Independent Seismic Evaluation of the Diablo Canyon Unit 1 Containment Annulus Structure and Selected Piping Systems

Brookhaven National Laboratory

Prepared for
U.S. Nuclear Regulatory
Commission

Manuscript Completed: May 1982
Date Published: August 1982

Figure 6.1 - URS/Blume mathematical model of containment annulus structure.

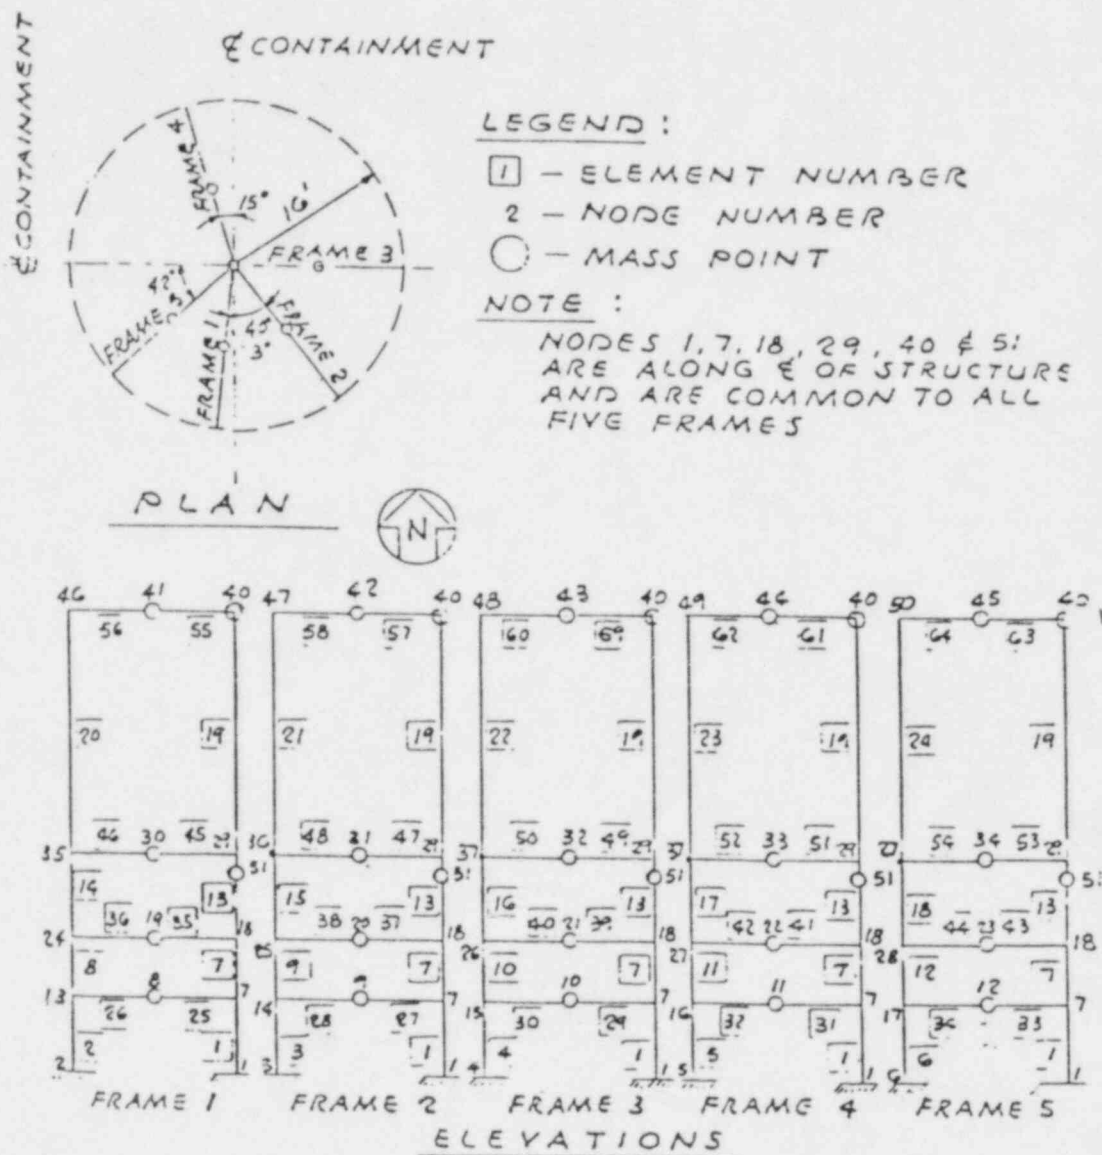
- (b) The computer printout sent to us (in April 1982) indicates zero mass density input for the structural members. It could be that member weights were meant to be included in the values of the lumped masses. However, if this were the case, then, again taking the third floor as an example, the total mass of all items supported by this floor as obtained from the corresponding drawings is approximately 7.54 Kip sec²/ft. This figure which does not include the mass of the structure itself already exceeds the value used in the URS/Blume computation.

- (c) A review of the steel fabricators drawings show that the member connections used in the 2-D URS/Blume model do not represent the conditions indicated in these drawings.
